Co3237 Poultney BF 0145(13)

ADDENDUM #1

- Invitation for Bids, and Proposal to extend Bid Opening to June 13, 2025, and update the Schedule of Items.
- Special Provision Pages 1 and 6.
- Plan sheets 3, 10, 11, 44-52, 57, 63, 65, 79-82, 93, 94, 96, and 97.
- New Impact Plans shall replace Pages 136 to 171 in the Proposal.

SCALE 1 1/2" = 1'-0"

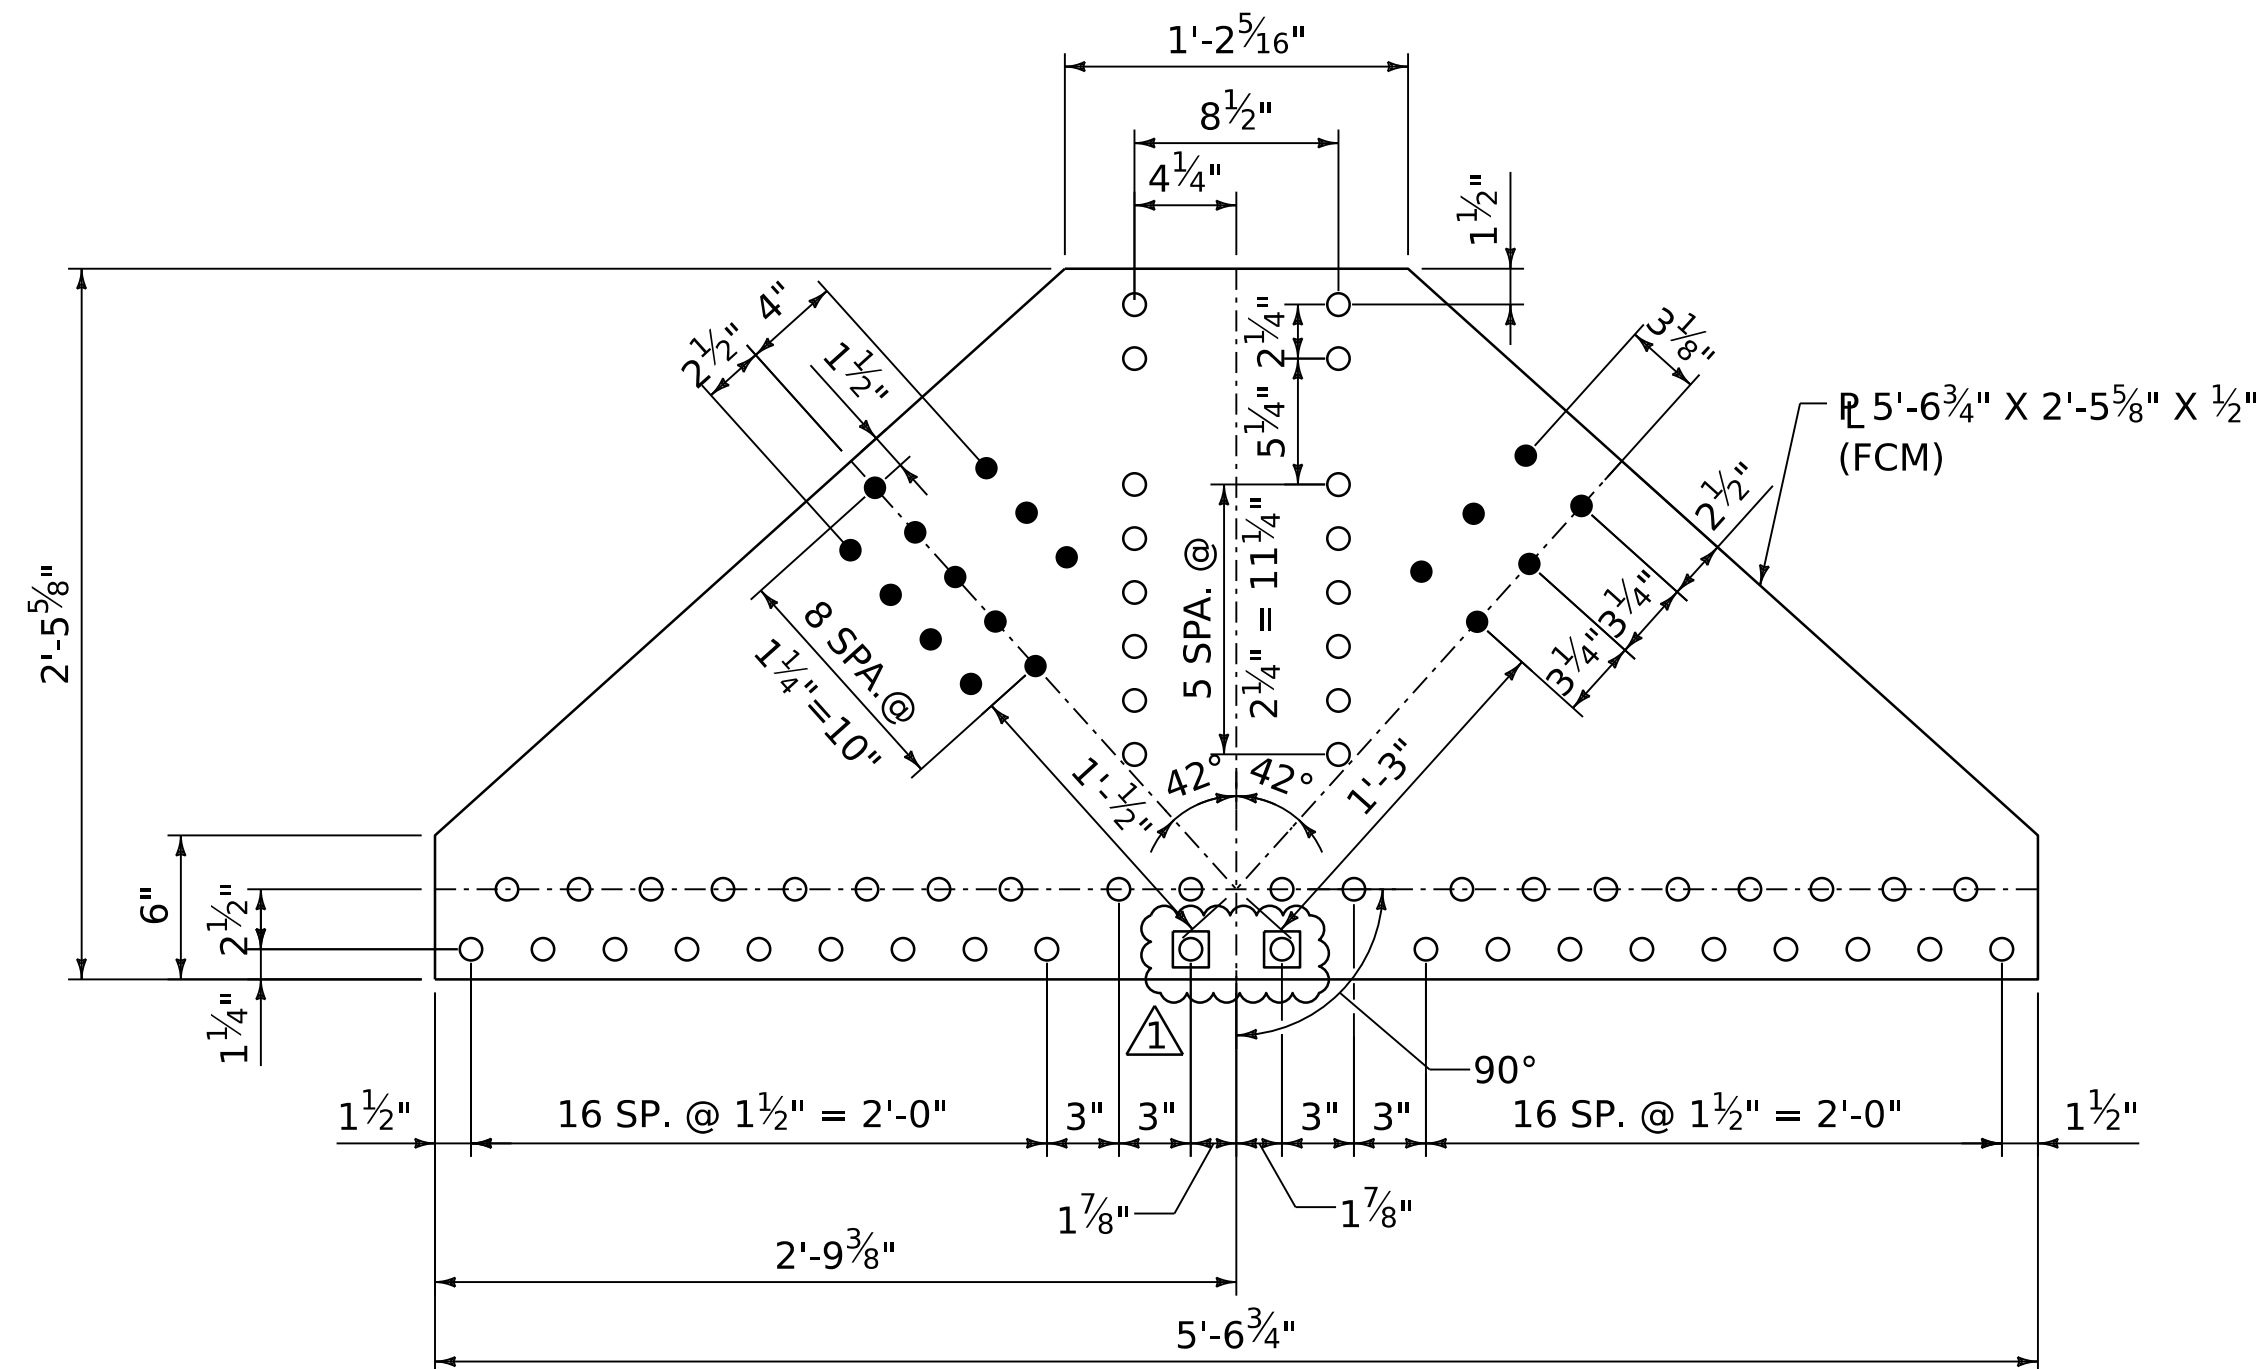
ADDENDUM	REVISION	PLOT DATE	DESCRIPTION	BY
⚠	1	5/19/2025	ADDED BOLTS TO EXTERIOR GUSSET PLATES	RHB

FILE NAME: z21j164floorbeam.dgn
PROJECT LEADER: J.D. KEENER
DESIGNED BY: N.A. TRUSLOW
FLOORBEAM DETAILS

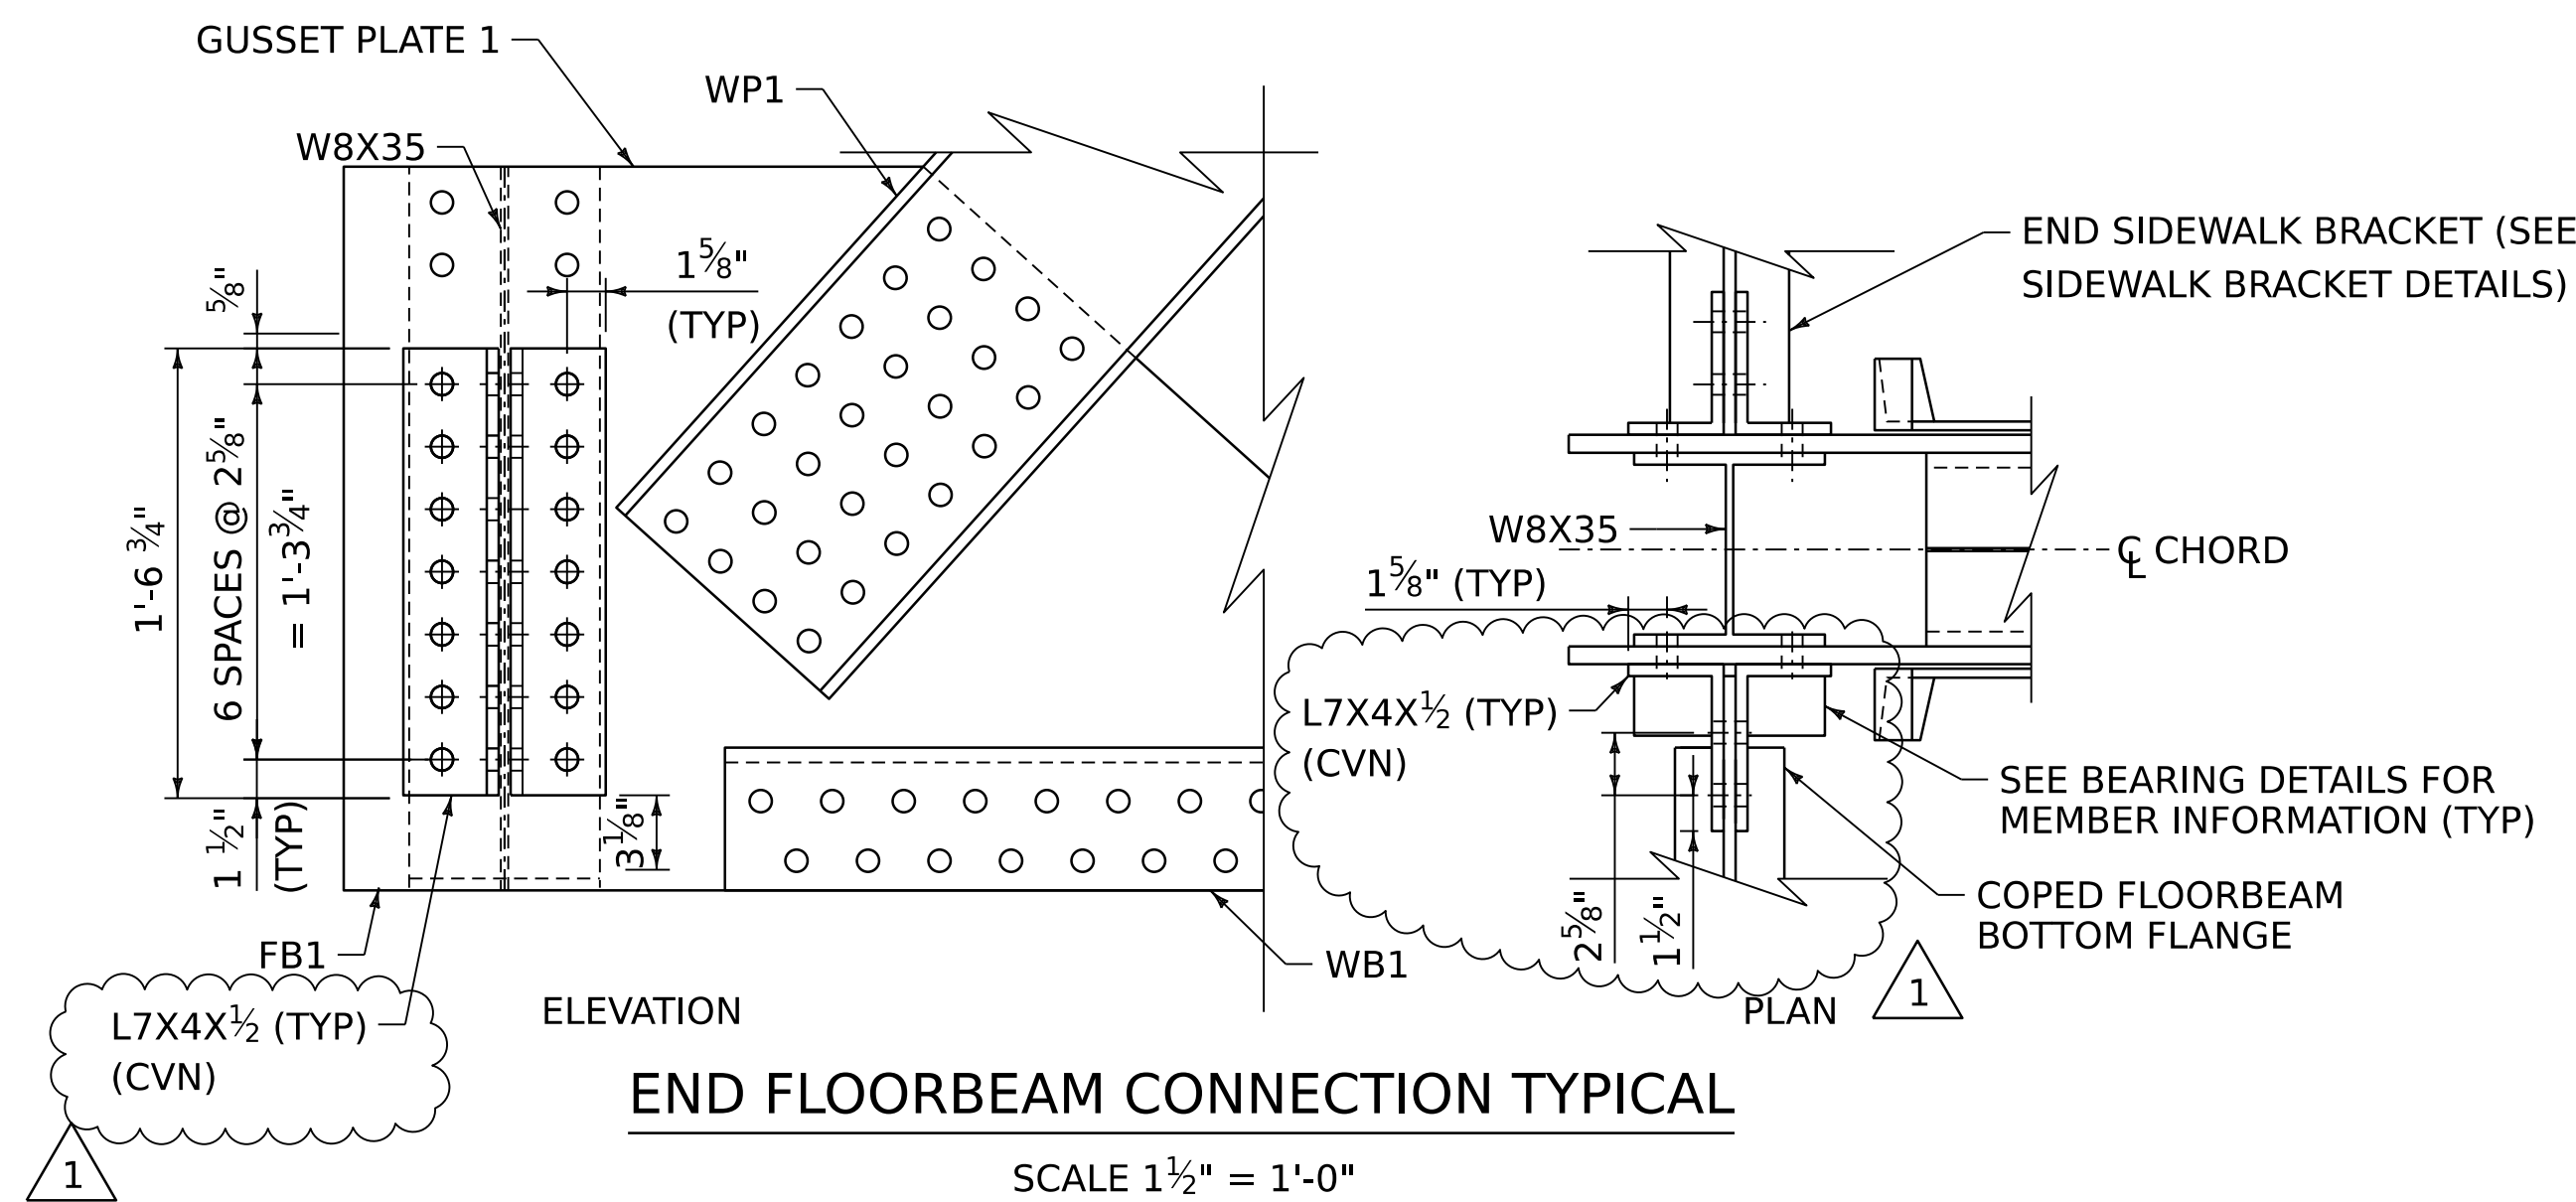
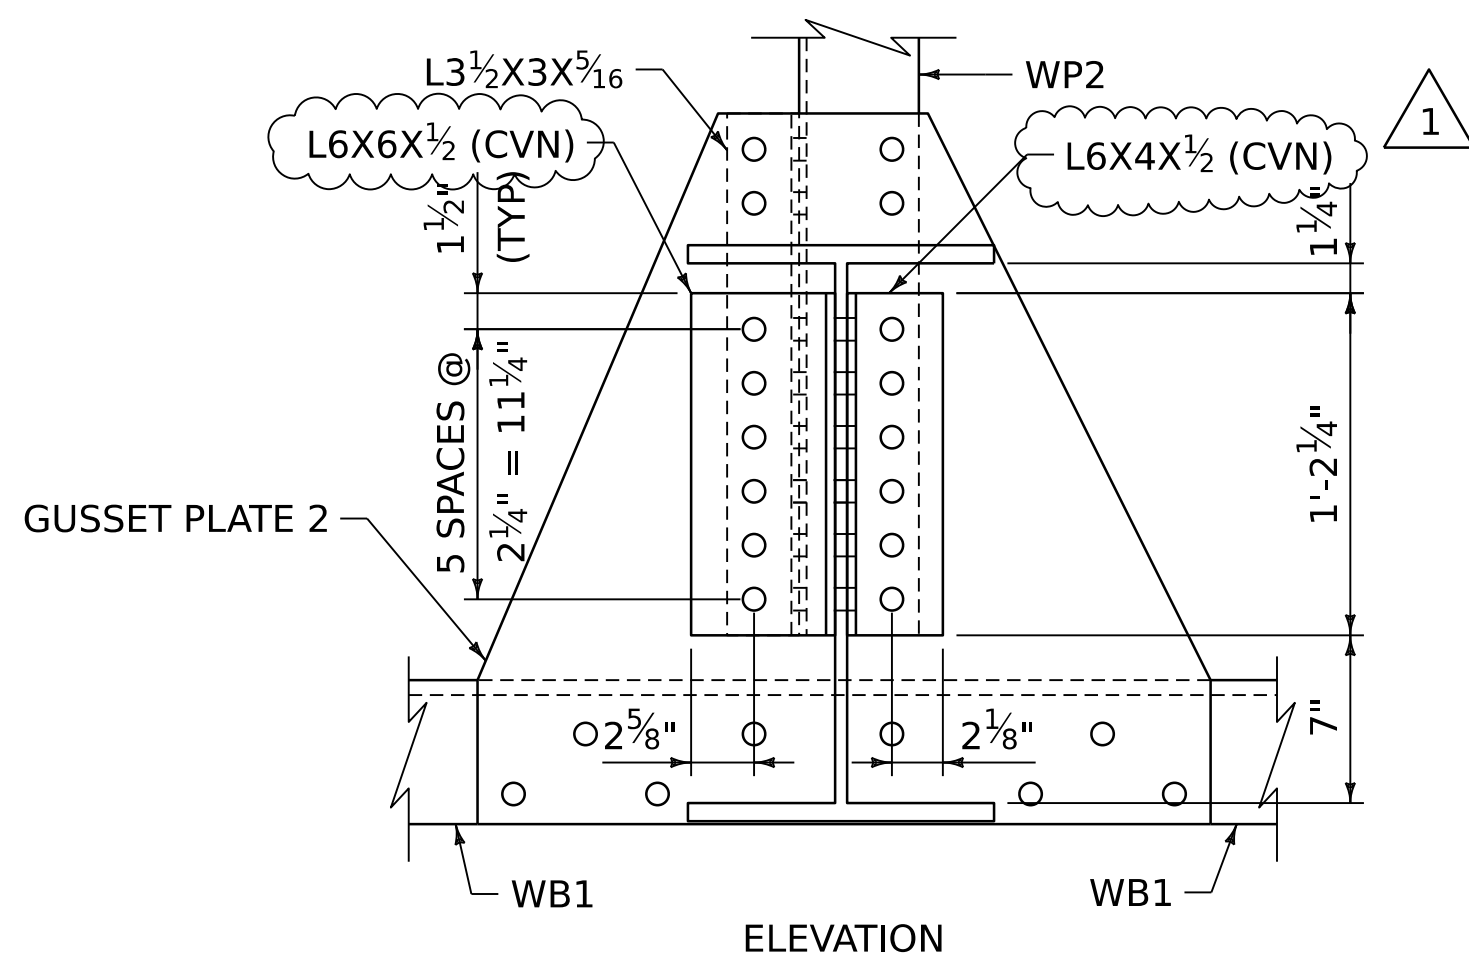
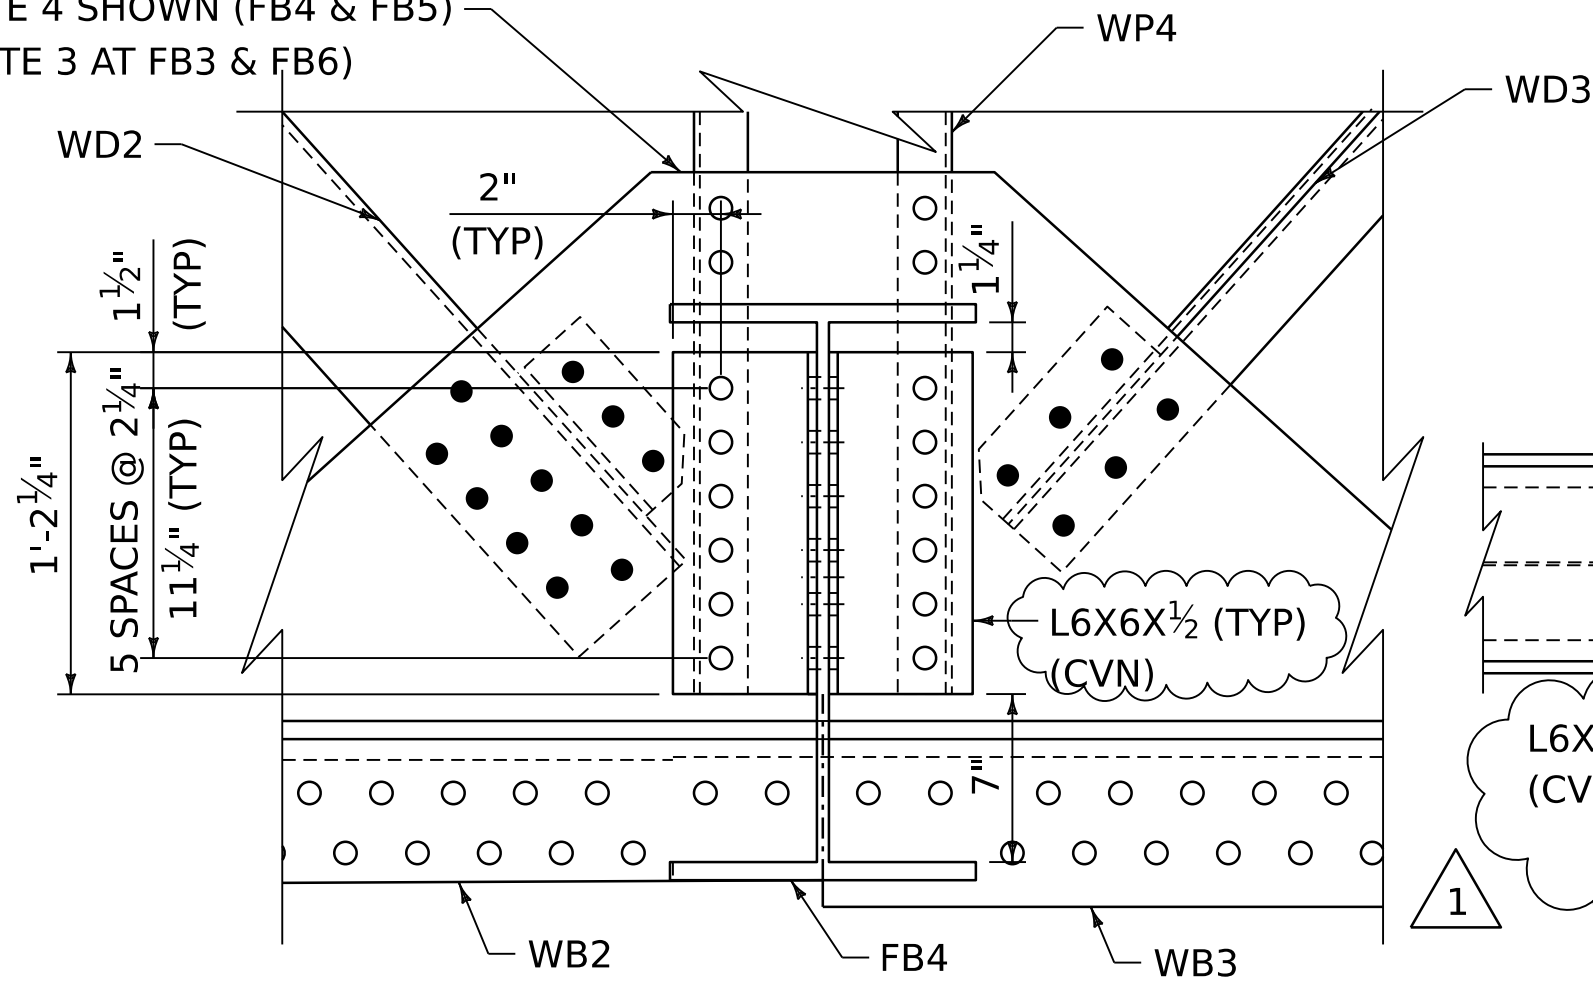
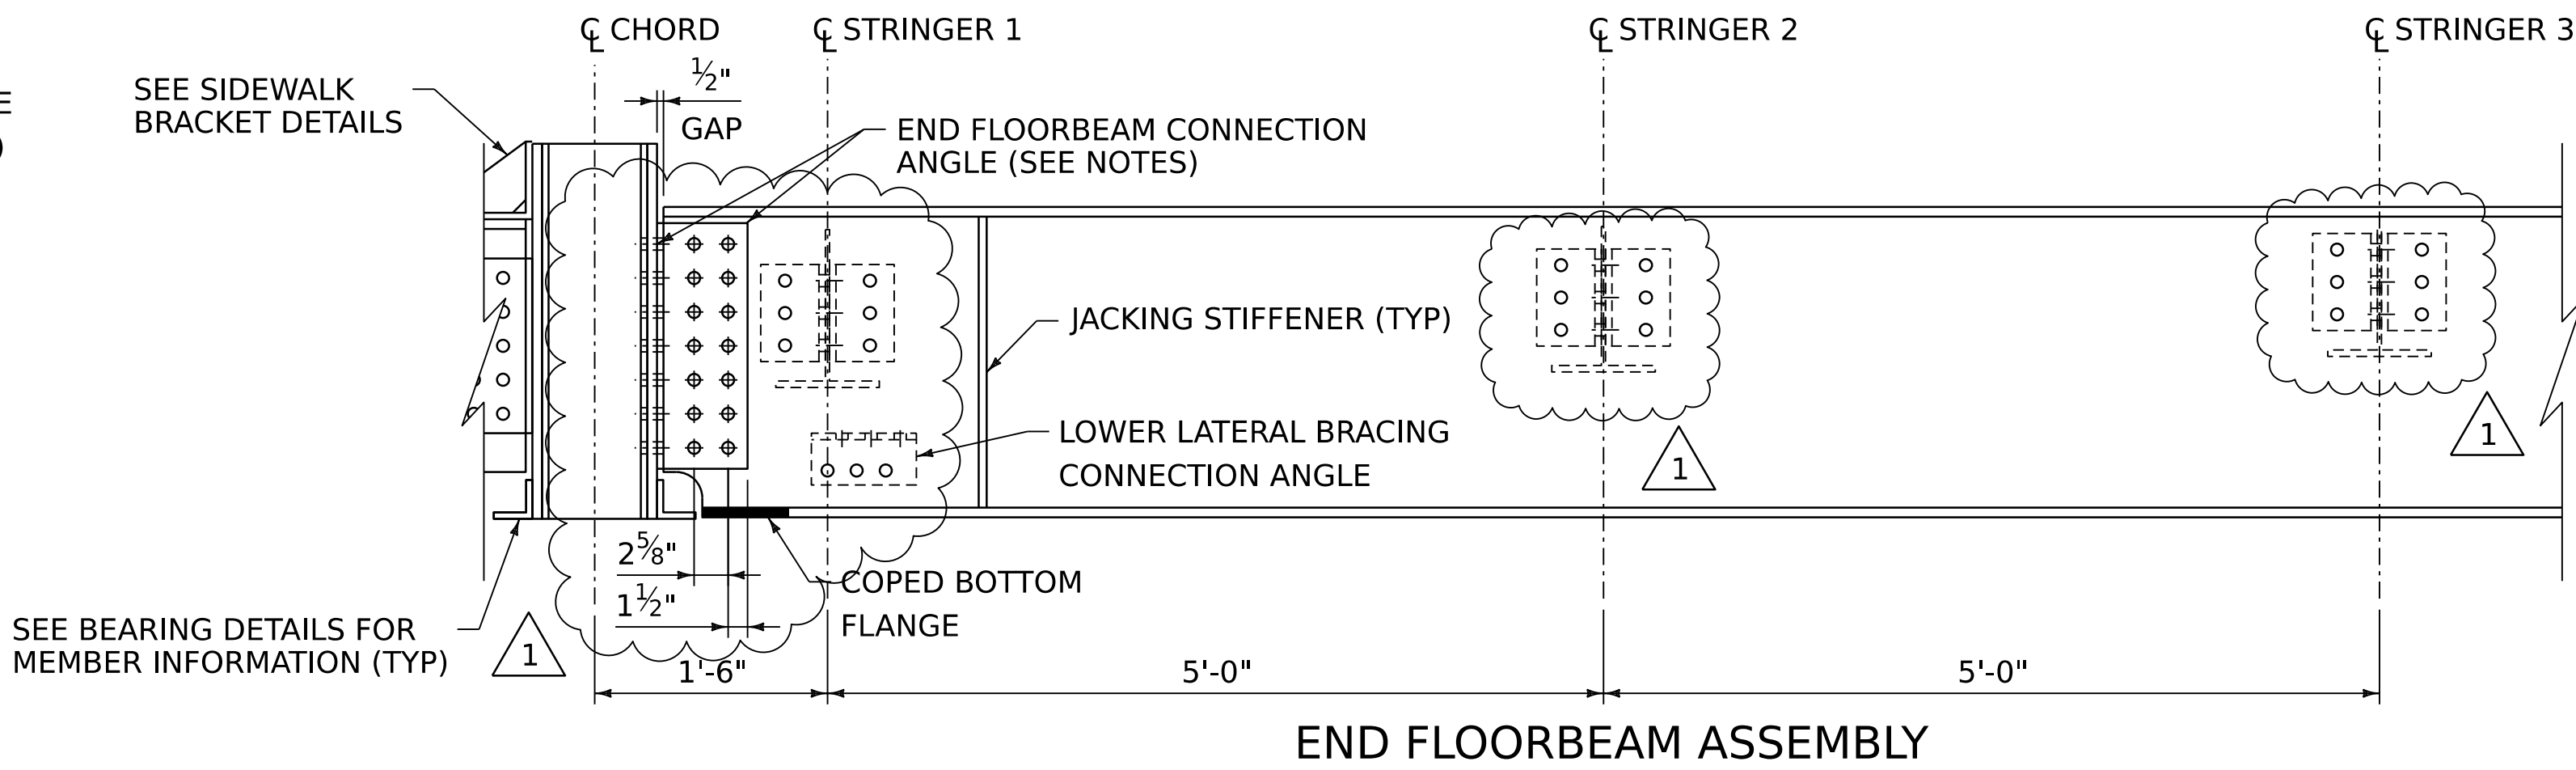
ADDENDUM	REVISION	PLOT DATE	DESCRIPTION	BY
1	1	5/19/2025	UPDATED SHEAR STUDS AND REVISED FLOORBEAM AND STRINGER CONNECTIONS	NAT
